UNITED STATES PATENT AND TRADEMARK OFFICE

APPLICATION NO.	FILING DATE	FIRST NAMED INVENTOR	ATTORNEY DOCKET NO.	CONFIRMATION NO.
09/960,712	09/21/2001	Stan J. Simpson	08998-00693	4279
37705	7590	07/06/2006	EXAMINER KUMAR, RAKESH	
GREENBERG TRAURIG, LLP 1200 SEVENTEENTH STREET, SUITE 2400 DENVER, CO 80202			ART UNIT 3654	PAPER NUMBER

Office Action Summary

Final Rejection

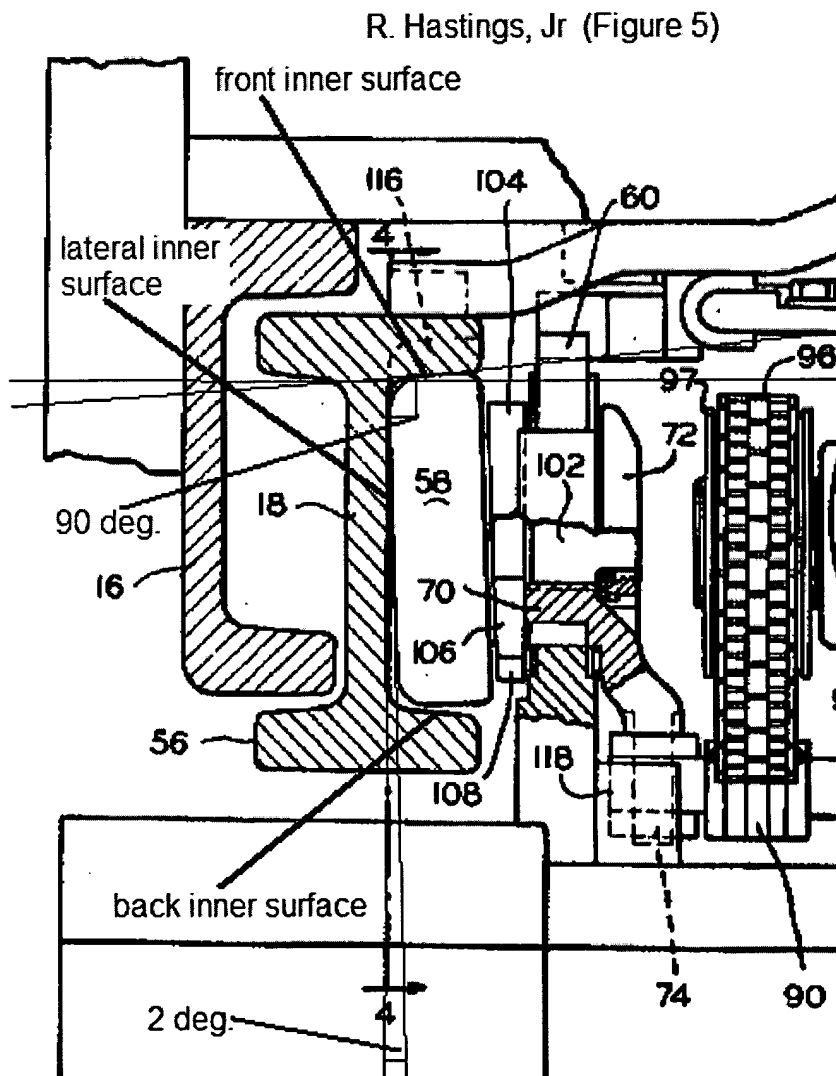
Hasting '853 discloses a mast for forklift truck comprising a carriage assembly 50, Fig. 2, having a first upper roller 64, a first lower roller 58, a second upper roller 64, and a second lower roller 58 and a front surface, and a first rail section, Fig. 5 including a first rail 18 and a second rail 18 positioned substantially parallel to each other, each rail 18 having a back inner surface (right hand portion in Figs 59) being substantially parallel to the front surface, a front inner surface (116) and a lateral inner surface (middle portion) adjacent to

the front inner surface and the lateral inner surface is substantially normal to the front surface, wherein each of the front inner surface and the lateral inner surface of respective first and second rails is about 92° .

Re claim 34, Fig. 5. shows a first rail comprises a first inner surface including a first back inner surface, a first front inner surface substantially opposite the first back inner surface, a first lateral inner surface that connects the first back inner surface and the first front inner surface; a second rail positioned substantially parallel to the first rail, where the second rail comprises a second inner surface including a second back inner surface, a second front inner surface substantially opposite the second back inner surface, and a second lateral inner surface that connects the second back inner surface and the second front inner surface; Figure 2 shows a carriage assembly comprising a first upper roller, a second upper roller positioned substantially opposite the first upper roller, a first lower roller, a second lower roller positioned substantially opposite the first lower roller, and a front surface; wherein the first upper roller and the first lower roller of the carriage assembly are operatively guided by the first inner surface of the first rail, and the second upper roller and the second lower roller of the carriage assembly are operatively guided by the second inner surface of the second rail, to cause the front surface of the carriage assembly to move along at least a portion of the length the first rail and the second rail; wherein the first lateral inner surface has a first front portion adjacent to first front inner surface and the second lateral inner surface has a second front portion adjacent to the second front inner surface, wherein the first front portion and the second front portion are substantially normal to the front surface; wherein the

intersection of the first front inner surface and the first front portion forms a first angle (see Figures 5-9) between the first front inner surface and the first front portion; wherein the first angle is greater than or equal to 90.5 degrees.

Re claim 37, see Figure 5.

Re claims 41-43, the relative difference between the first angle and the second angle is about 1.0 degree.

JP "092 (Figure 6)

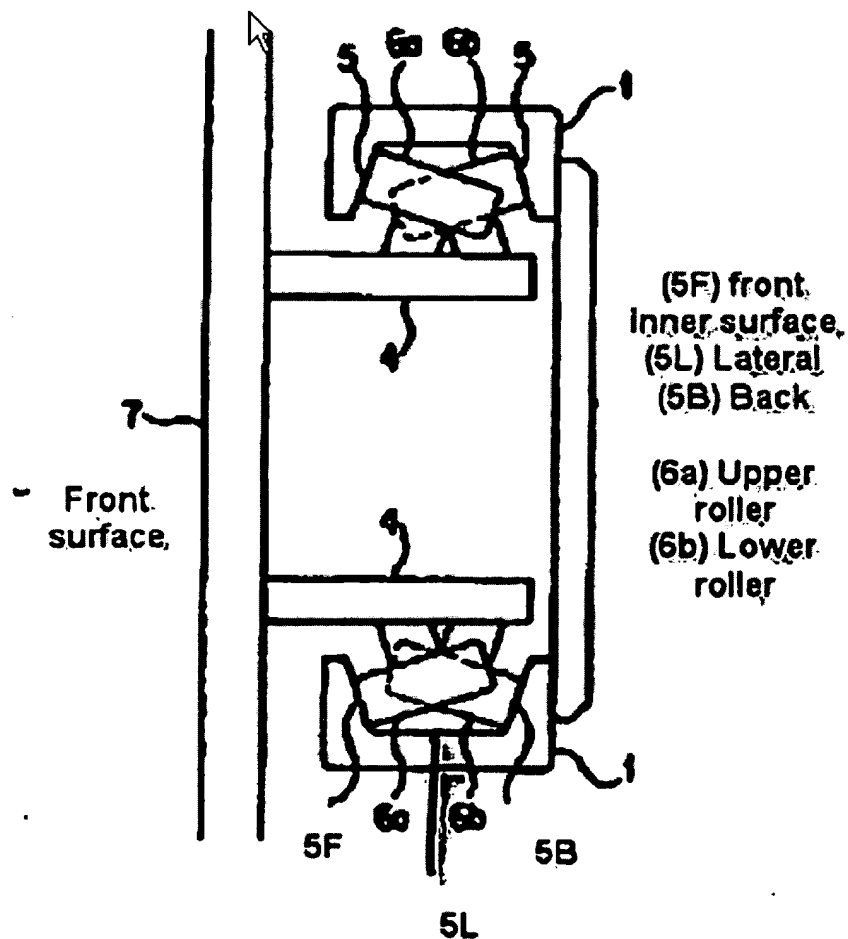
JP'092 discloses a mast for forklift truck comprising a first rail (Figure 6) comprises a first inner surface including a first back inner surface, a first front inner surface substantially opposite the first back inner surface, a first lateral inner surface that connects the first back inner surface and the first front inner surface; a second rail positioned substantially parallel to the first rail, where the second rail comprises a second inner surface including a second back inner surface, a second front inner surface substantially opposite the second back inner surface, and a second lateral inner surface that connects the second back inner surface and the second front inner surface; a carriage assembly comprising a first upper roller, a second upper roller positioned substantially opposite the first upper roller, a first lower roller, a second lower roller positioned substantially opposite the first lower roller, and a front surface; wherein the first upper roller and the first lower roller of the carriage assembly are operatively guided by the first inner surface of the first rail, and the second upper roller and the second lower roller of the carriage assembly are operatively guided by the second inner surface of the second rail, to cause the front surface of the carriage assembly to move along at least a portion of the length the first rail and the second rail; wherein the first lateral inner surface has a first front portion adjacent to first front inner surface and the second lateral inner surface has a second front portion adjacent to the second front inner surface, wherein

the first front portion and the second front portion are substantially normal to the front surface; wherein the intersection of the first front inner surface and the first front portion forms a first angle (see Figures 5-9) between the first front inner surface and the first front portion; wherein the first angle is greater than or equal to 90.5 degrees.

JP '092 discloses a mast for forklift comprising a carriage assembly having a first upper roller 6a, Figure 6, a first lower roller 6b, a second upper roller 6a, and a second lower roller 6b and a front surface, and an inner rail section comprising a first rail 1 and a second rail 1 positioned substantially parallel to each other, each rail 1 having a back inner surface, a front inner surface and a lateral inner surface (middle portion) that are capable of operatively guiding said carriage assembly along at least a portion of the length of the inner rail section, wherein the first upper roller and second upper roller on said carriage assembly are positioned relative to the front surface at an angle greater than or equal to 90.5° , wherein the front inner surface of the first guide rail and the second guide rail are positioned relative to the front surface at an angle of greater than 90.0° .
